ADDENDUM NO. 2

September 30, 2022

Woods Lake - A Magnet Center for the Arts Remodeling & Site Improvements

**Woods Lake Elementary
3215 Oakland Drive
Kalamazoo, MI, 49008**

WATER SOFTENER DETAIL - DUPLEX

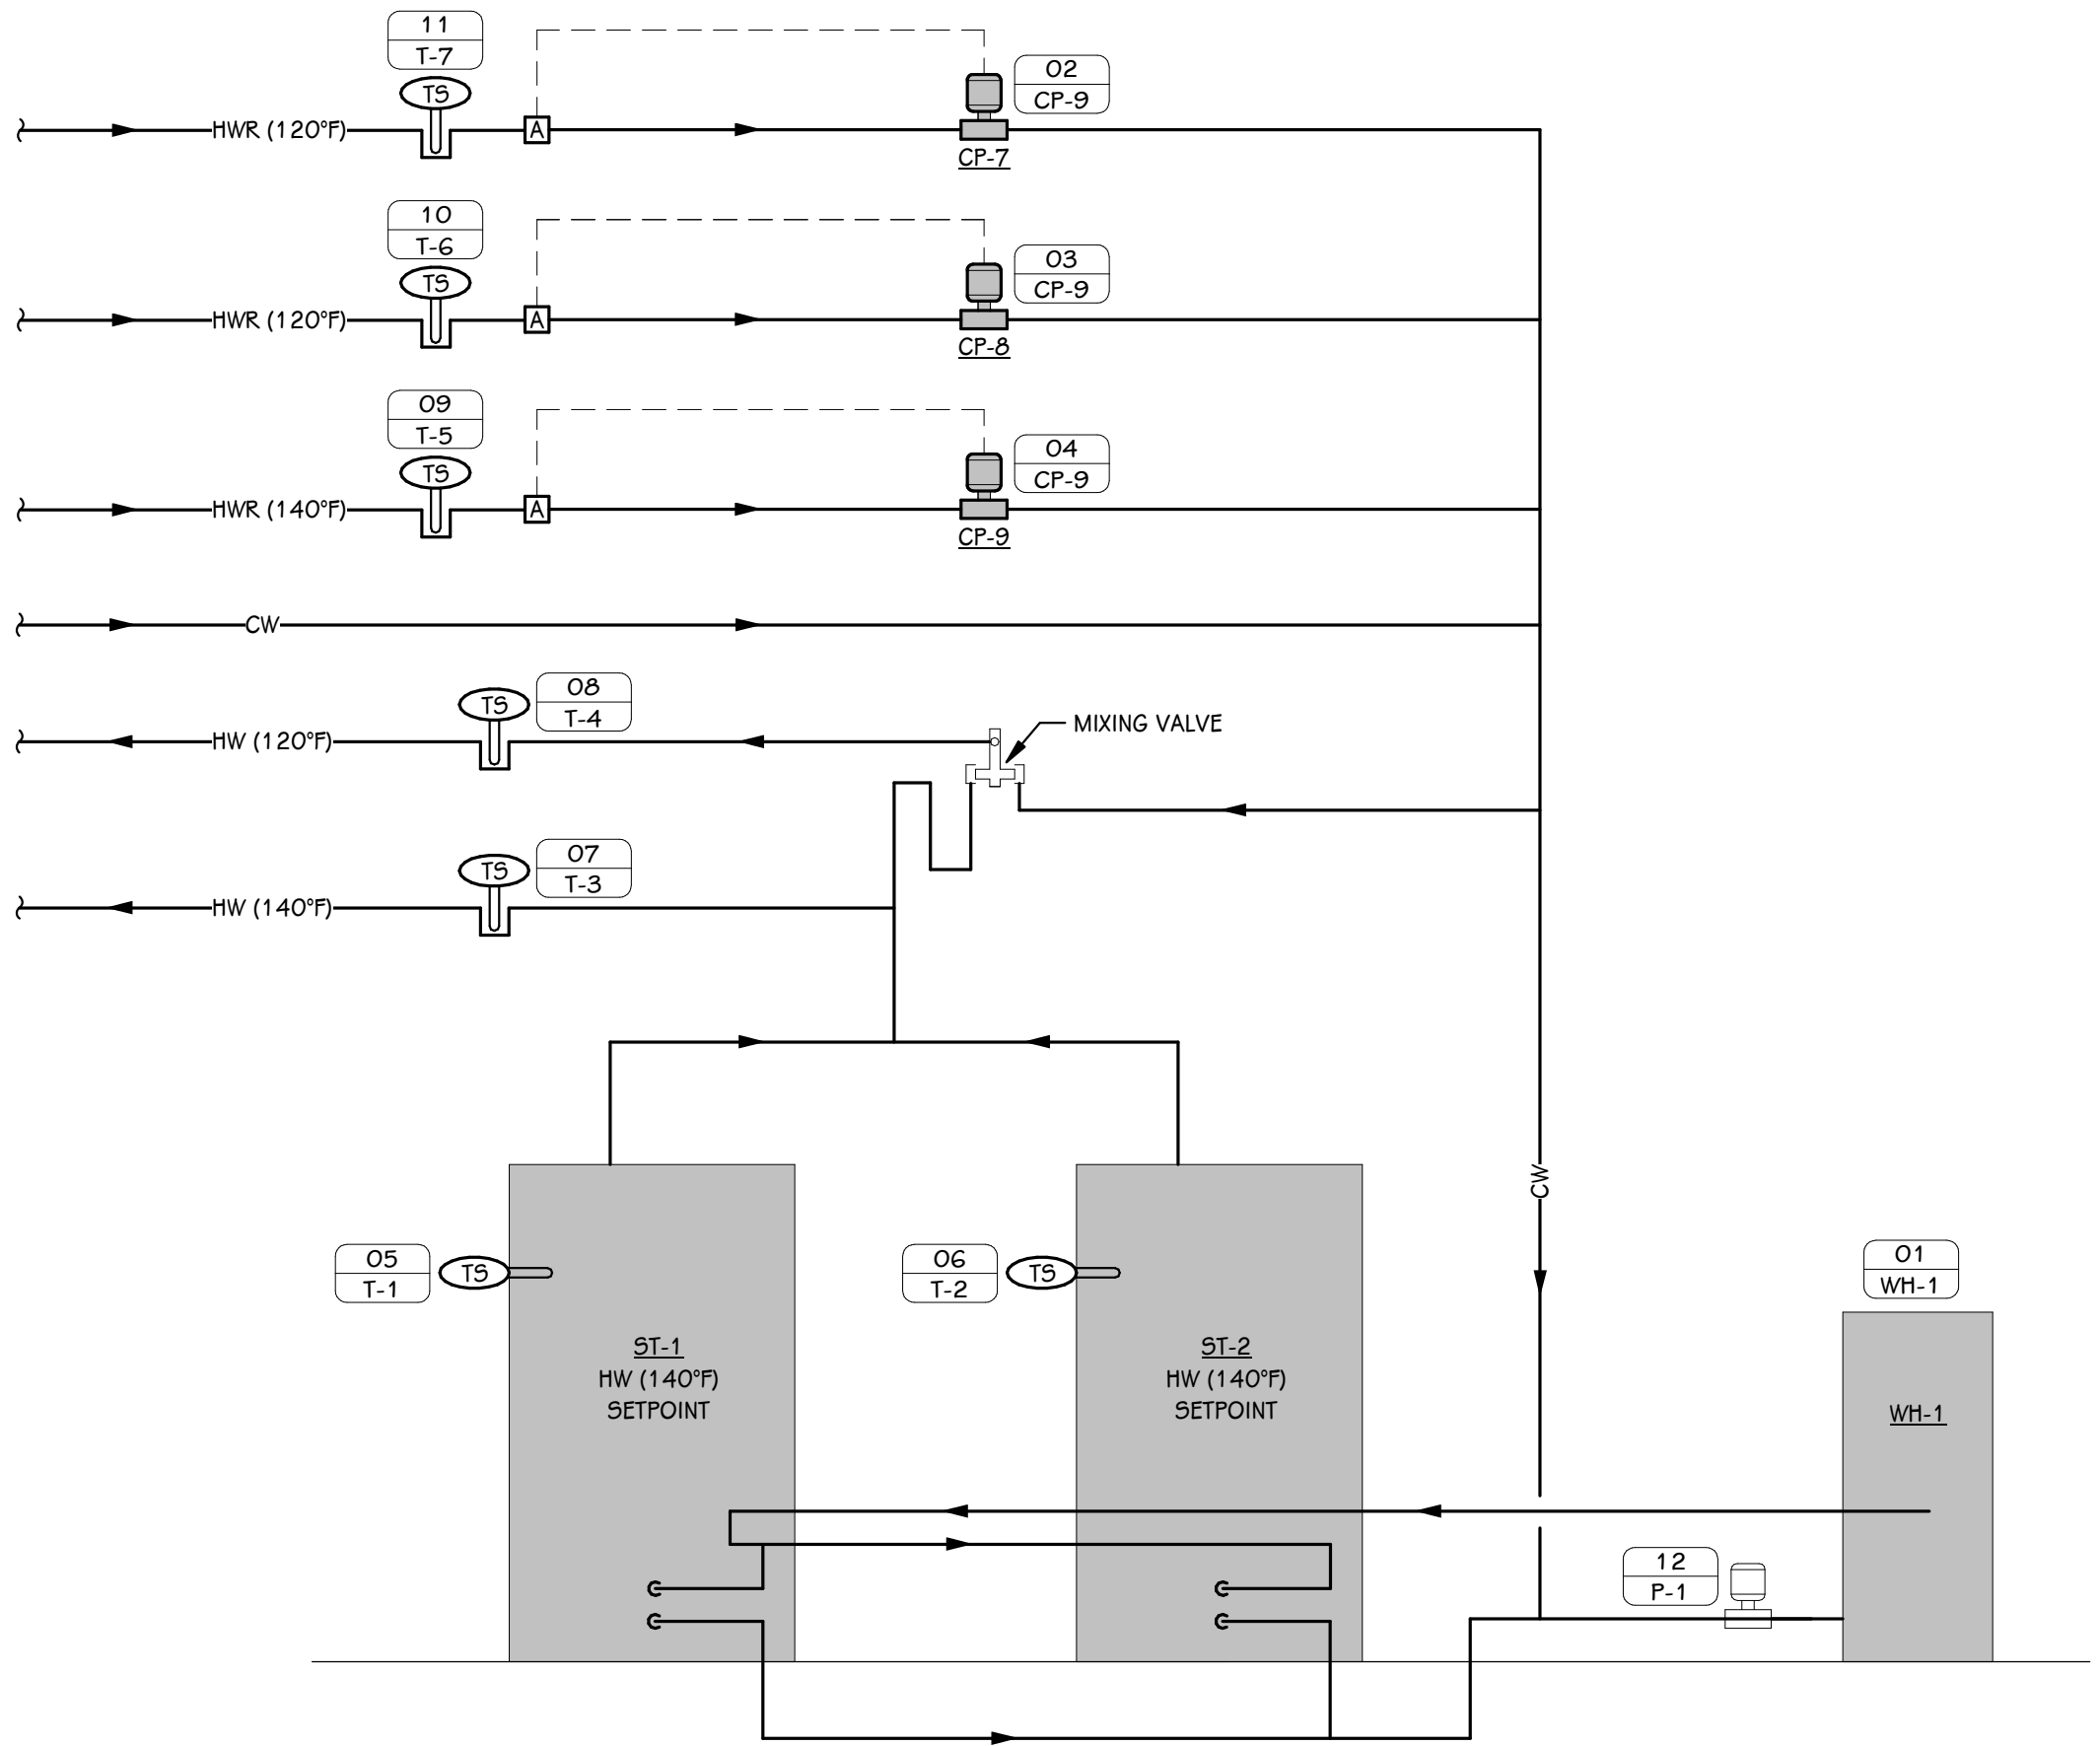
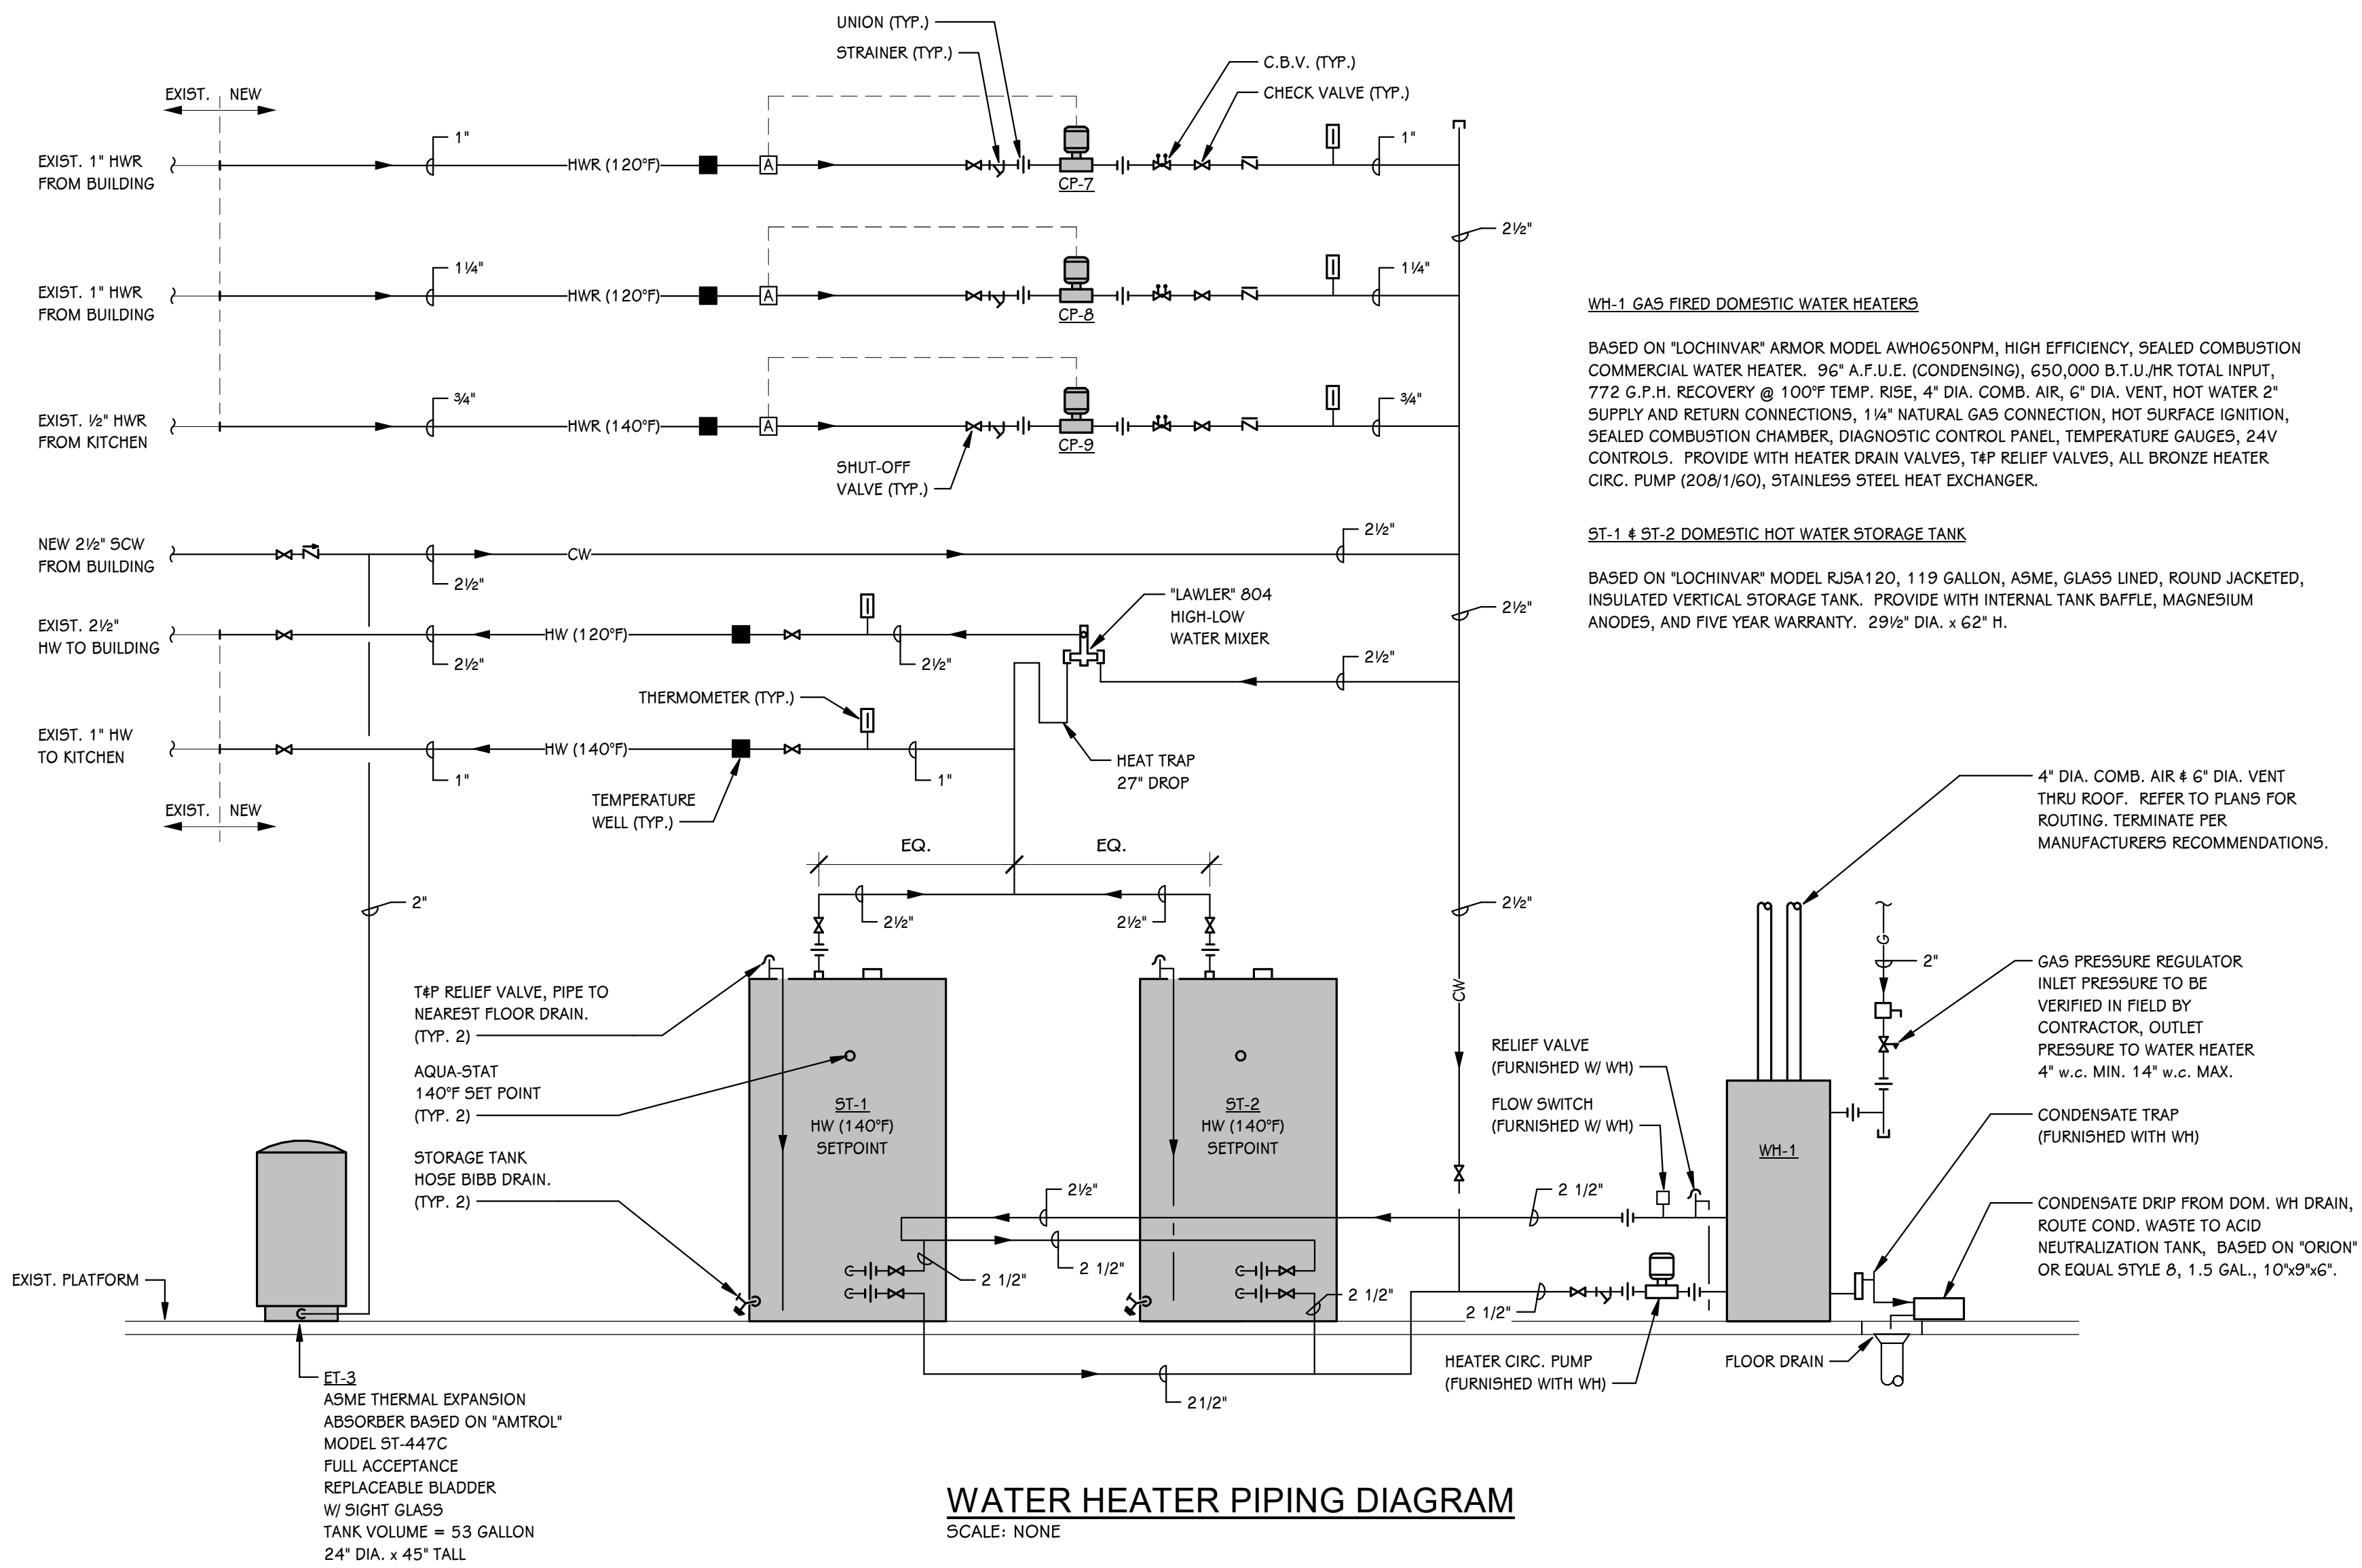
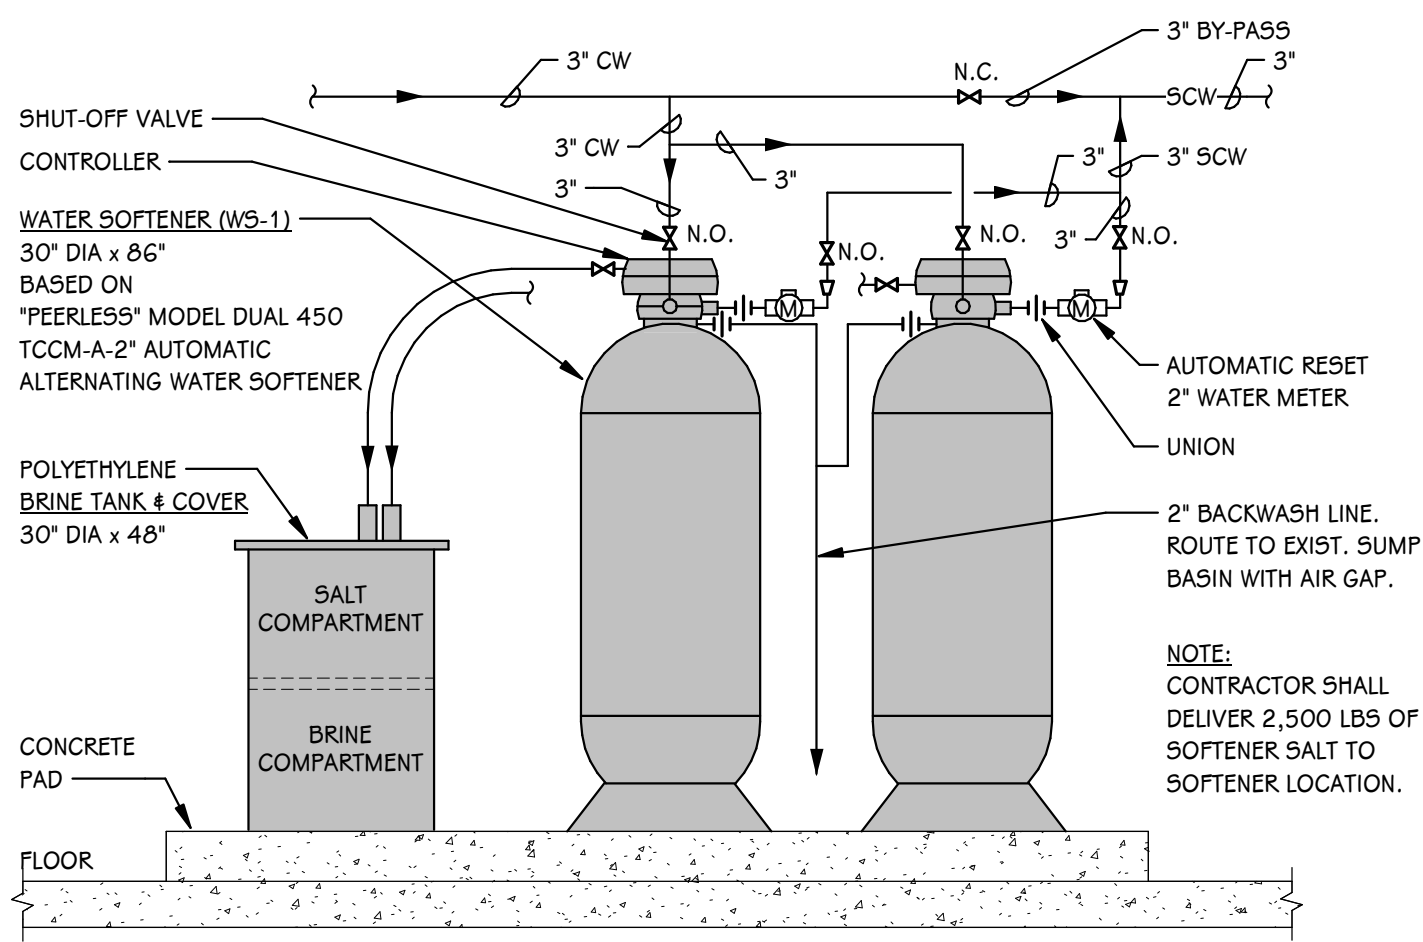
ADD-2 Item No. D-3 - New Domestic Water Softener

Added new domestic water softener and associated piping as indicated on drawings.

ADD-2 Item No. D-4 - Domestic Water Heater Piping and Controls

Added piping and controls associated with new domestic water heater and storage tanks.
